# COLUMBUS AVENUE STREET REDESIGN

*Recommendations for Mitigating Unintended Impacts*

**February 2011**

**Columbus Avenue Working Group**

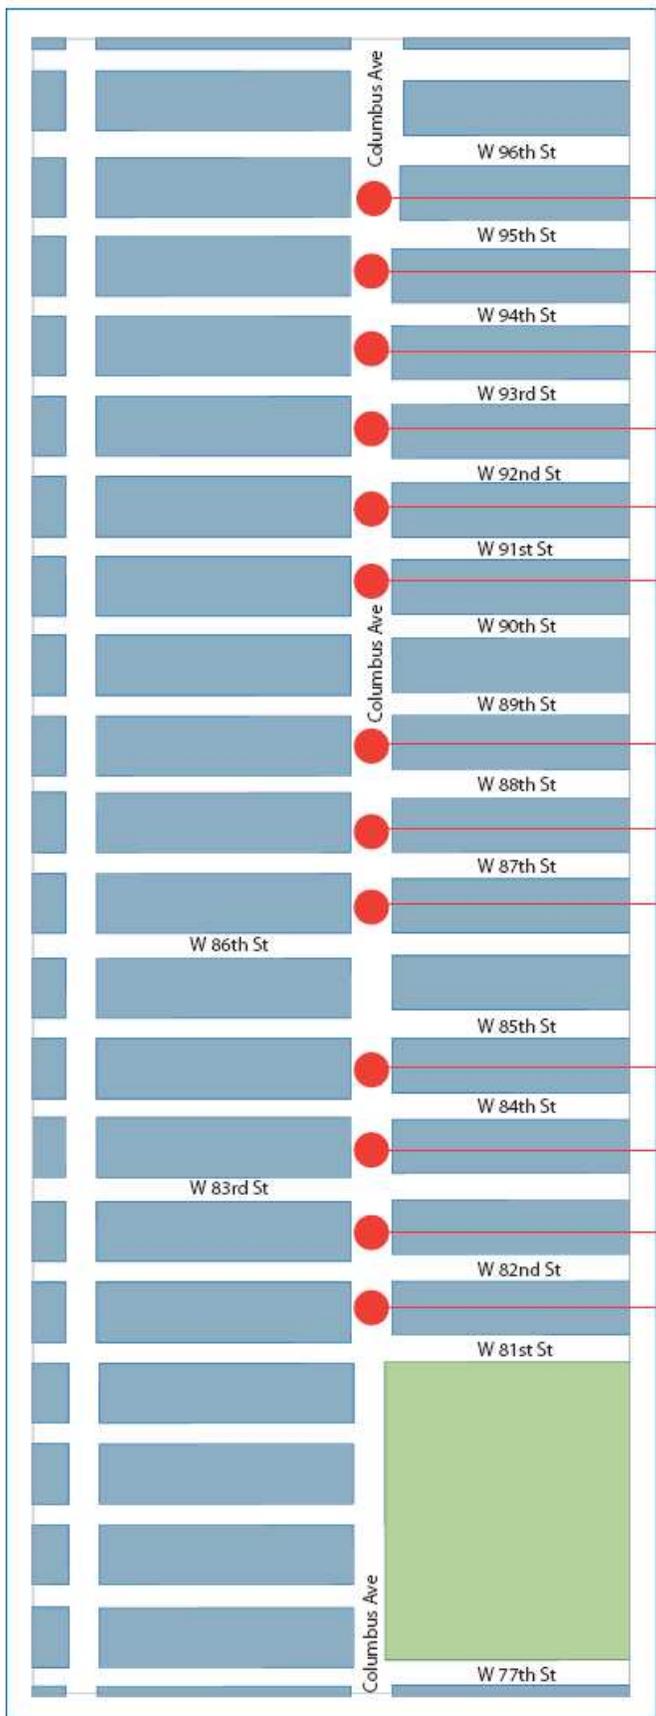
Consult with businesses on loading and parking needs

Investigate reducing the mixing lane

Consult with businesses on loading and parking needs  
Add "No Idling" street sign in front of 689 Columbus Avenue

Investigate reducing the mixing lane

Consult with businesses on loading and parking needs

Investigate reducing the mixing lane

Consult with businesses on loading and parking needs  
Investigate reducing the mixing lane  
Replace "No Standing" with an "Ambulette Only" sign

Consult with businesses on loading and parking needs

Investigate reducing the turning lane  
Consult with businesses on loading and parking needs

Investigate removing or allowing parking in front of 1 fire hydrant

Consult with businesses on loading and parking needs

Investigate reducing the mixing lane

Investigate reducing the turning lane  
Enforce city-issued parking placard misuse
